Proposed Technical Specification Revised Pages

**TMI-1 Technical Specification Change Request No. 272 Safety Evaluation
No Significant Hazards Consideration and
Proposed Technical Specification Revised Pages**

Revised Technical Specification Pages: vii, 3-8, 3-9, 3-9b, 3-9c, 4-9

FIGURE 3.1-2a

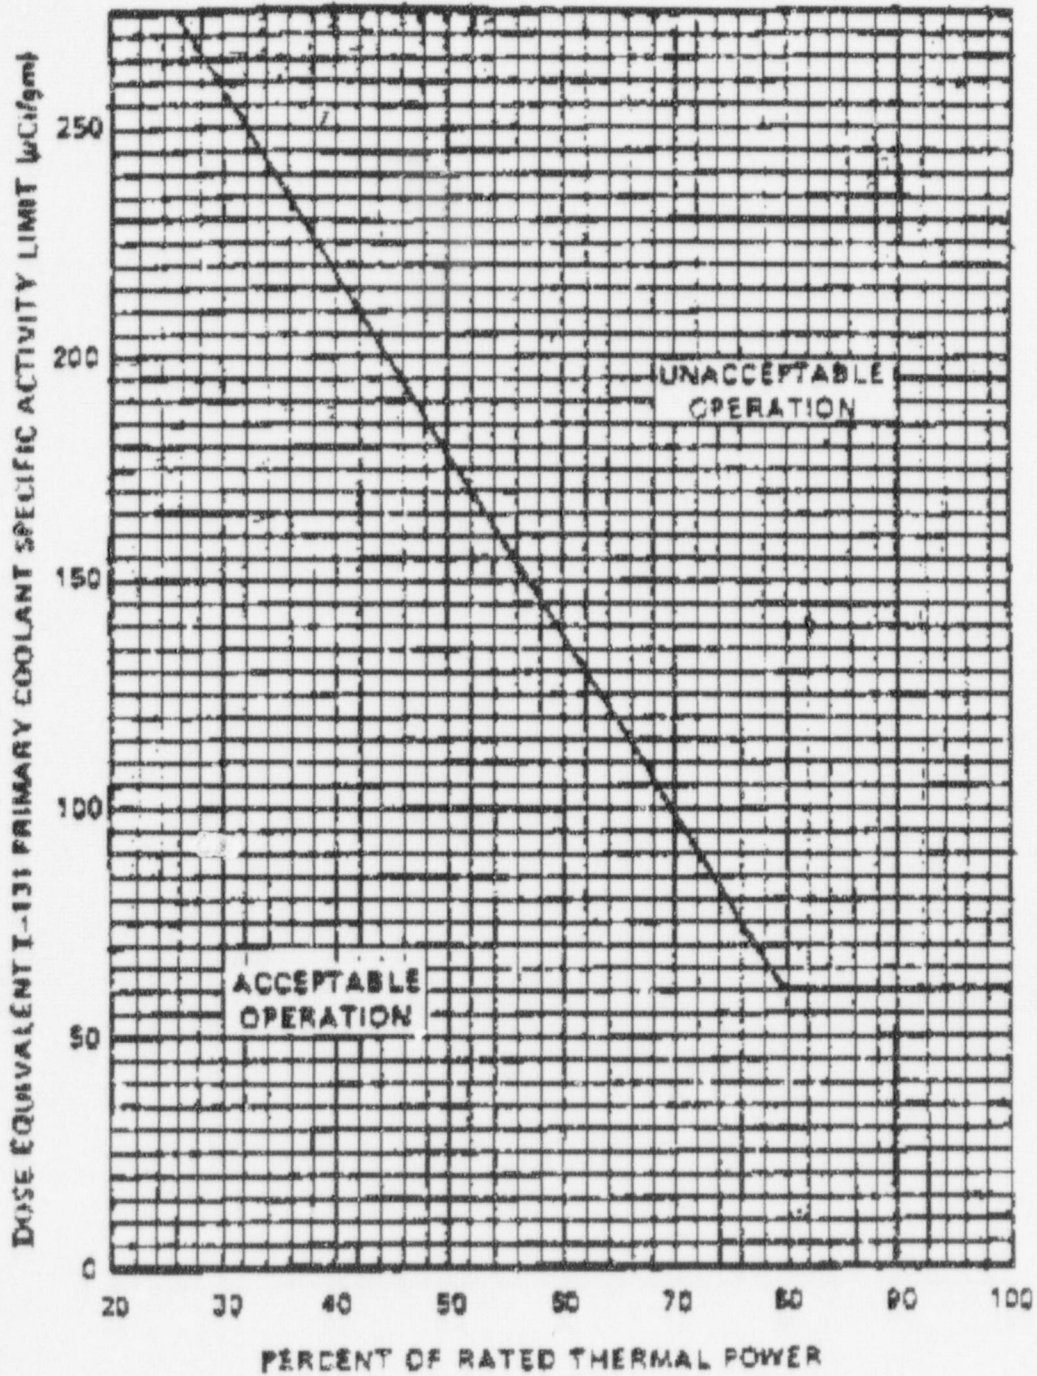
- a. With the specific activity of the primary coolant greater than the most restrictive DOSE EQUIVALENT I-131 limit specified on Figure 3.1-2b, for more than 48 hours** during one continuous time interval or exceeding the limit line shown on Figure 3.1-2a, be in at least HOT SHUTDOWN within 6 hours. Power operation may continue when DOSE EQUIVALENT I-131 is below the most restrictive limit specified on Figure 3.1-2b.
- b. With the specific activity of the primary coolant greater than $100/\bar{E}$ microcuries/gram be in at least HOT SHUTDOWN within 6 hours. Power operation may continue when primary coolant activity is less than $100/\bar{E}$ microcuries/gram.

The ACTION statement permitting POWER OPERATION to continue for limited time periods with the primary coolant's specific activity greater than the limit specified in 3.1.4.1.a, but within the allowable limit shown on Figure 3.1-2a, accommodates possible iodine spiking phenomenon which may occur following changes in THERMAL POWER.

Figure 3.1-2b

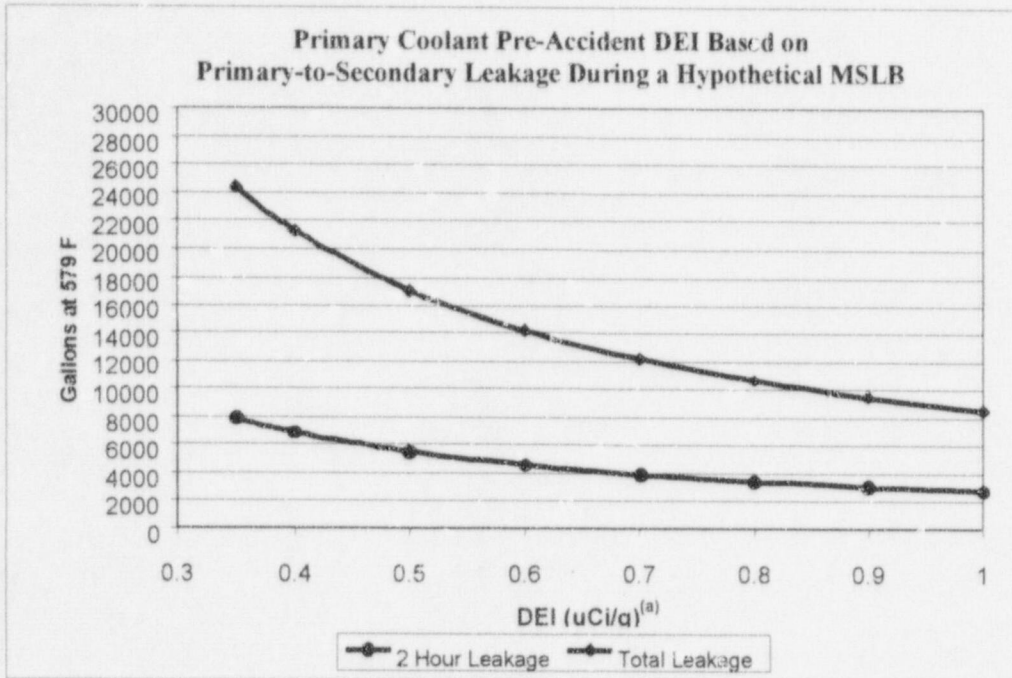
- a. Less than or equal to the most restrictive DOSE EQUIVALENT I-131 limit specified on Figure 3.1-2b, and
- b. Less than or equal to $100/\bar{E}$ microcuries/gram*

- c. With the specific activity of the primary coolant greater than the most restrictive DOSE EQUIVALENT I-131 limit specified on Figure 3.1-2b, or greater than $100/\bar{E}$ microcuries/gram perform the sampling and analysis requirements of Table 4.1-3 until the specific activity of the primary coolant is restored to within its limits.

The purpose of this Technical Specification Change Request is to revise the TMI-1 Technical Specification limit on reactor coolant system specific activity contained in Technical Specification Section 3.1.4 and Table 4.1-3. The proposed change revises the reactor coolant system specific activity limit from 0.35 microcurie/gram dose equivalent iodine I-131 to a cycle specific dependent value based on the once-through steam generator (OTSG) inspection results performed each refueling outage, with a maximum allowable limit of 1.0 microcurie/gram dose equivalent iodine I-131. The proposed maximum allowable limit of 1.0 microcurie/gram ($\mu\text{Ci}/\text{gm}$) dose equivalent iodine I-131 was the TMI-1 Technical Specification limit prior to Cycle 12 startup (October 1997).
